REMARKS

Review and reconsideration of this application are respectfully requested in view of the above amendments and, particularly in view of the following discussion.

FIG.2
HYSTERESIS
PRESSURE SWITCH

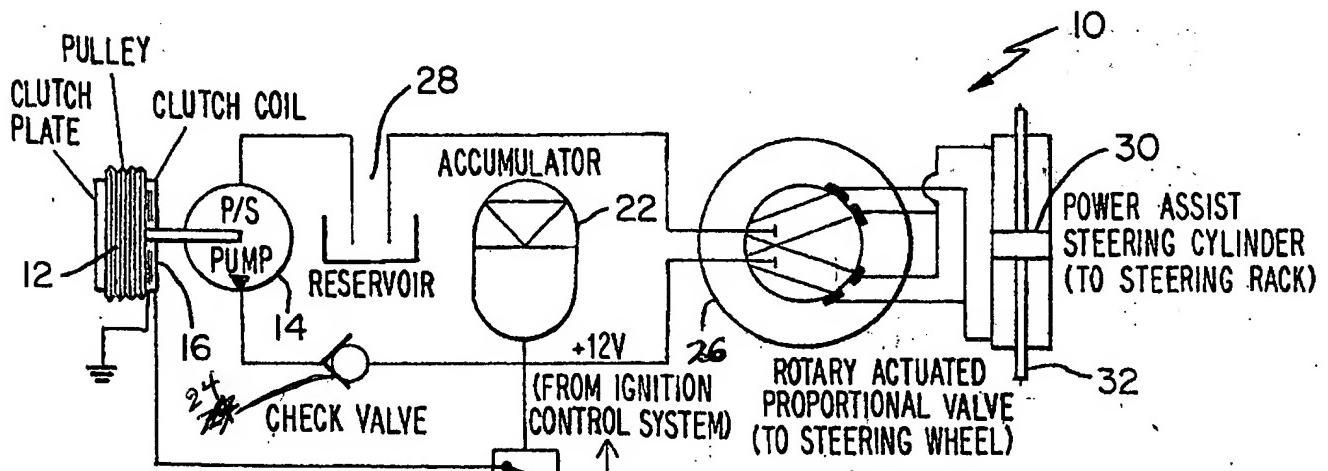
(5) that the drawings are objected to under 37 CFR 1.83(a) in that the drawings must show every feature of the invention specified in the claims, e.g., the claimed "hydraulic pump driven by a belt" (claim 1) and the claimed "controlling means...integrated into the hydraulic accumulator" (claims 21 and 24) must be shown or the feature(s) canceled from the claim(s).

With respect to (5) above, applicant has now amended claims 1 and 15 to describe the hydraulic pump as being operably connected to said pulley rather than being driven by a belt. Concerning the "controlling means...integrated into the hydraulic accumulator" shown in claims 21 and 24, applicant has amended claim 21 to depend from claim 3 rather than claim 1 and has amended the term "controlling means" to "hysteresis pressure switch". Claim 24 has also been amended to change the term "controlling means" to "hysteresis pressure switch". These amendments to claims 21 and 24 should now be withdrawn since the specification clearly states that the hysteresis pressure switch may be separate from or integrated with the hydraulic accumulator.
